Serial No 15-297
NSSL/MLC R0
Docket Nos. 50-336/50-423
License Nos. DPR-65/NPF-49

DOMINION NUCLEAR CONNECTICUT, INC.
MILLSTONE POWER STATION UNITS 2 AND 3
LICENSE AMENDMENT REQUEST FOR REMOVAL OF SEVERE LINE OUTAGE
DETECTION FROM THE OFFSITE POWER SYSTEM

1. Evaluation of Proposed License Amendments (MPS2 and MPS3)
2. Mark-up of Proposed FSAR Changes (MPS2)
3. Mark-up of Proposed FSAR Changes (MPS3)
4. New Technical Requirement for Offsite Line Power Sources, For Information Only (MPS2)
5. New Technical Requirement for Offsite Line Power Sources, For Information Only (MPS3)
6. ISO-New England Millstone Facility Out Guide Letter
7. Historical Regulatory Correspondence Pertaining to MPS3 Offsite Power Sources

FIGURE 8.1-1A - DELETED

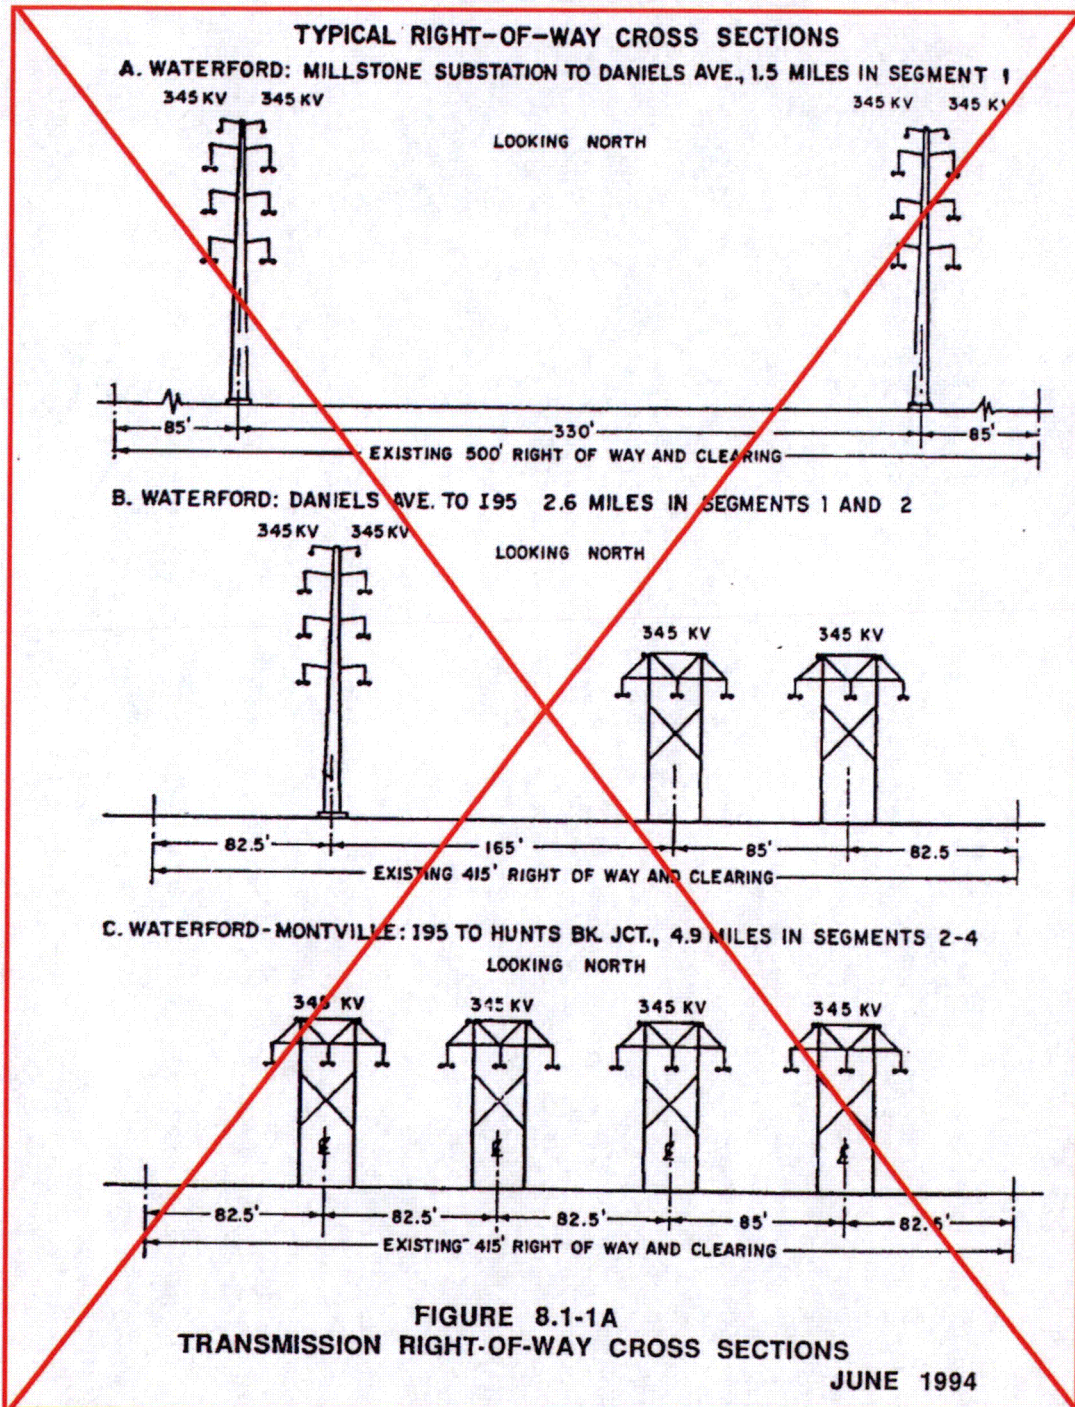
FSAR Figures 8.1-1A (MPS2) and 8.2-1(MPS3) are being deleted since the DCT design has been modified to SCTs and they no longer provide useful information. The four lines are now on SCTs of various designs. Showing a simplified sketch of the various types of SCTs is unnecessary.

FIGURE 8.1-1B HUNTS BROOK JUNCTION

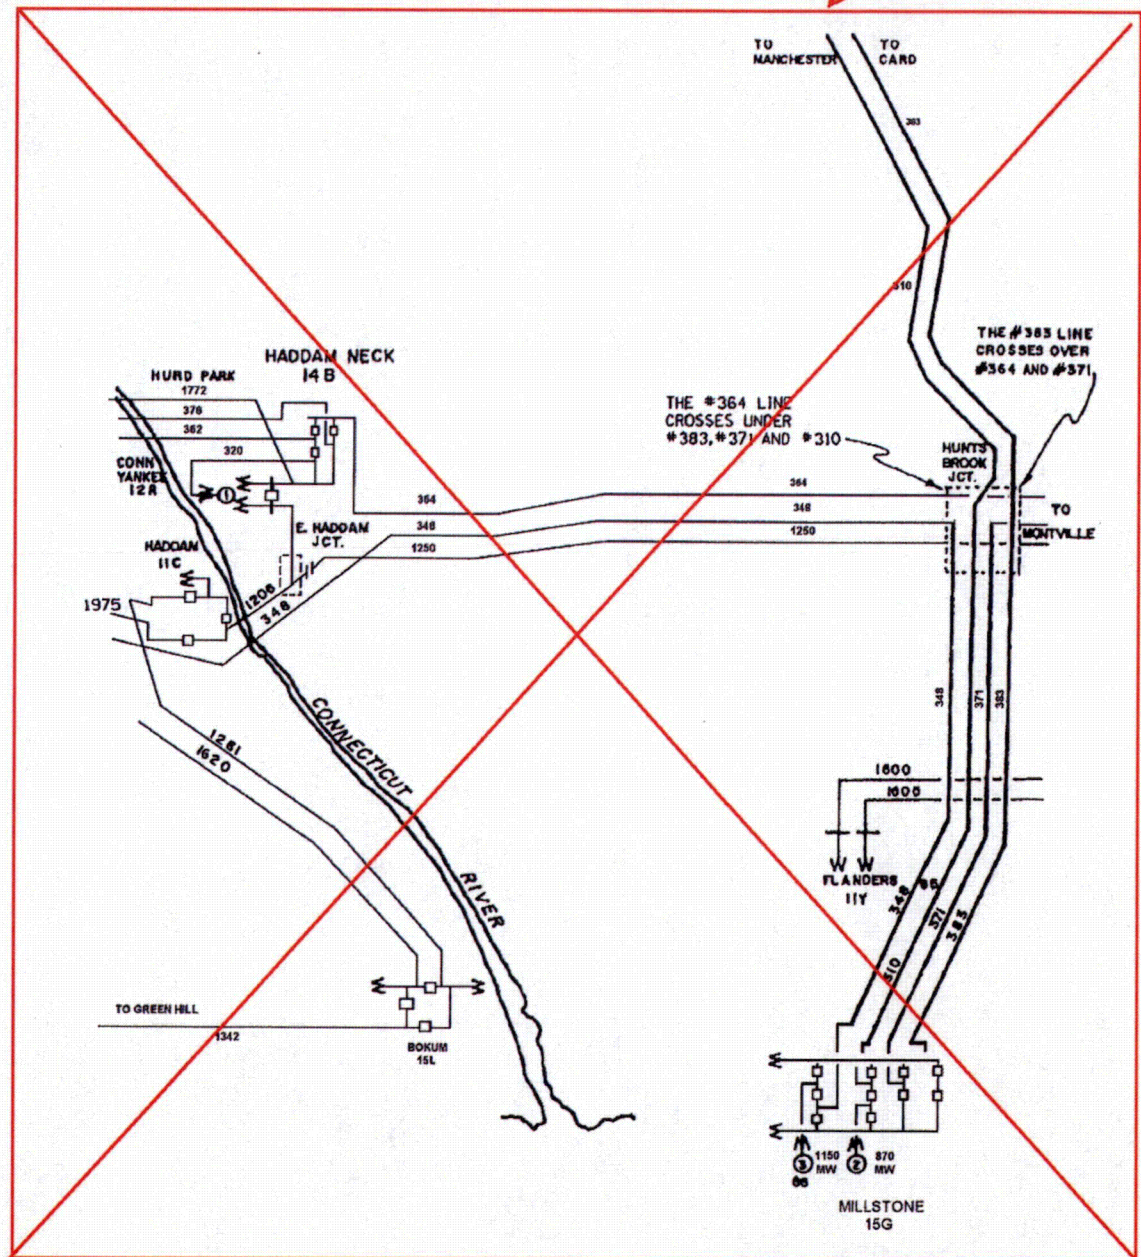
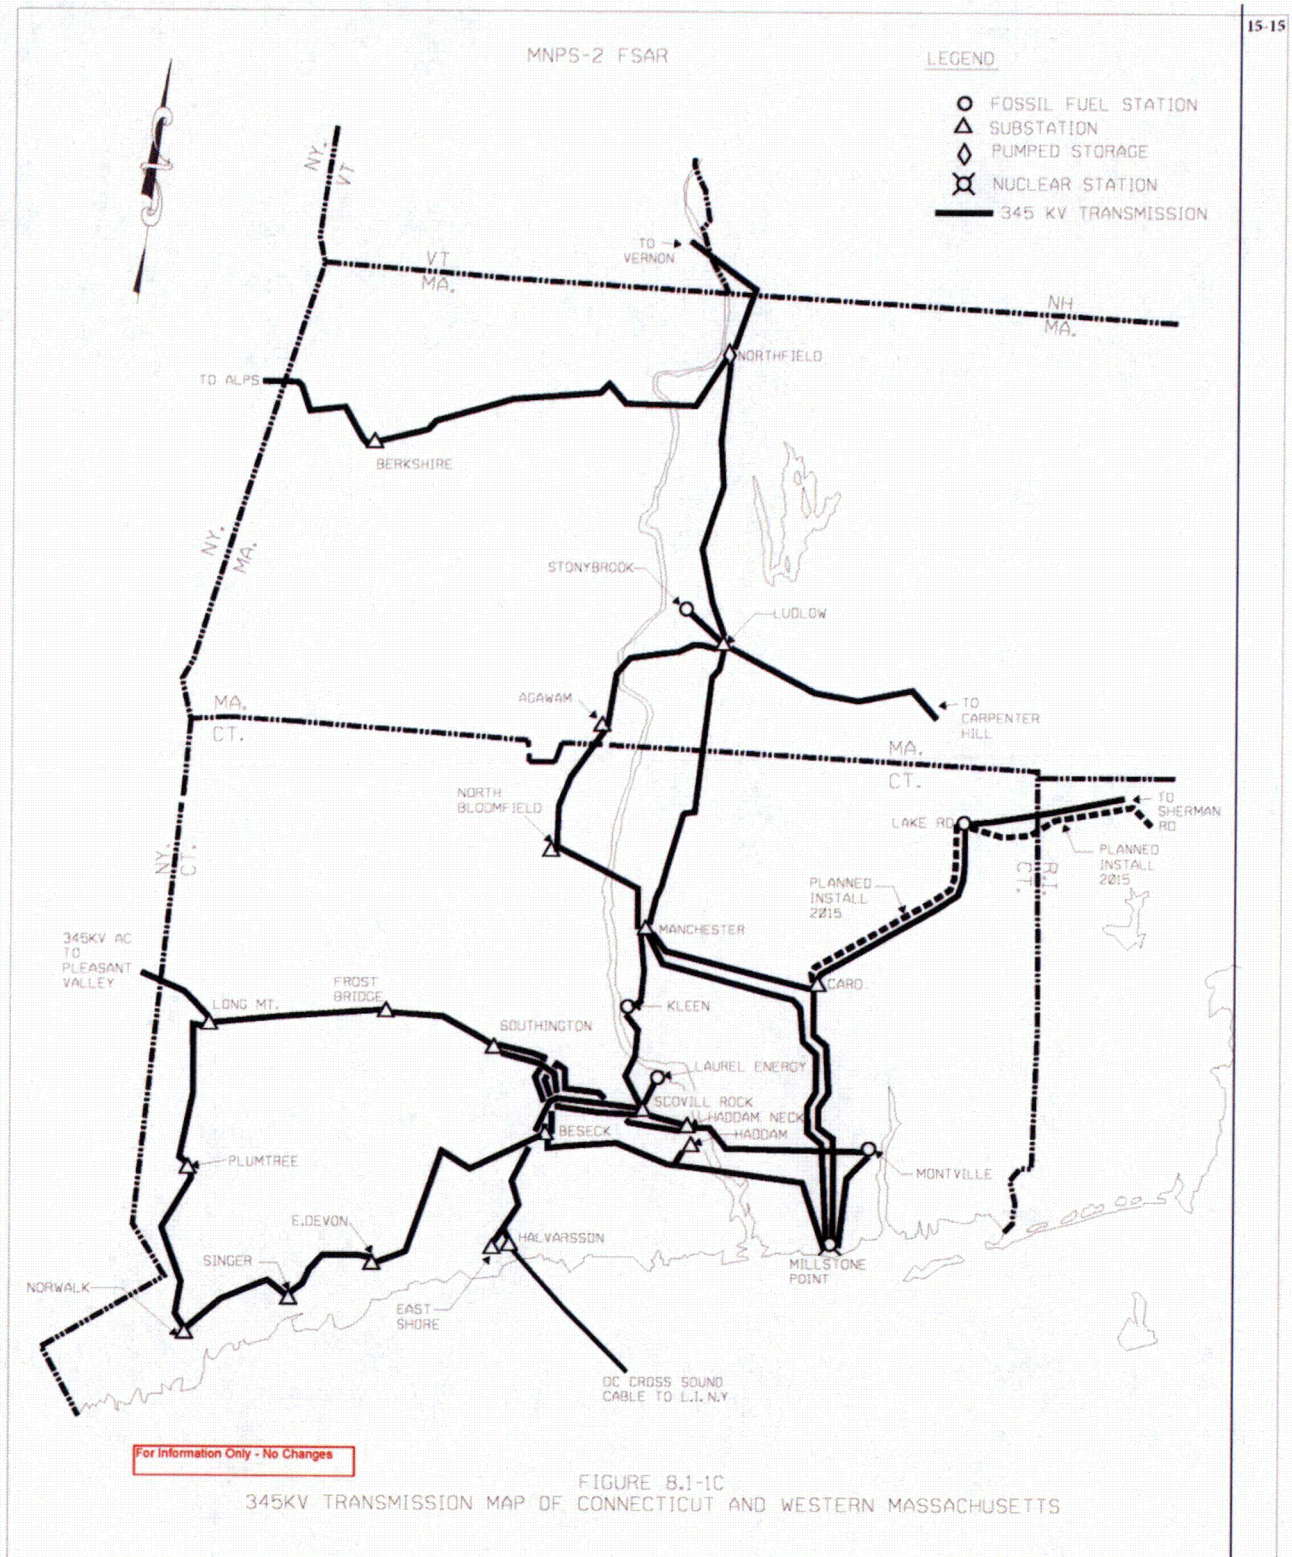
Replace with INSERT A

Note: This figure replaces existing MP2 FSAR Figure 8.1-1B and MP3 FSAR Figure 8.2-2

Hunts Brook Junction
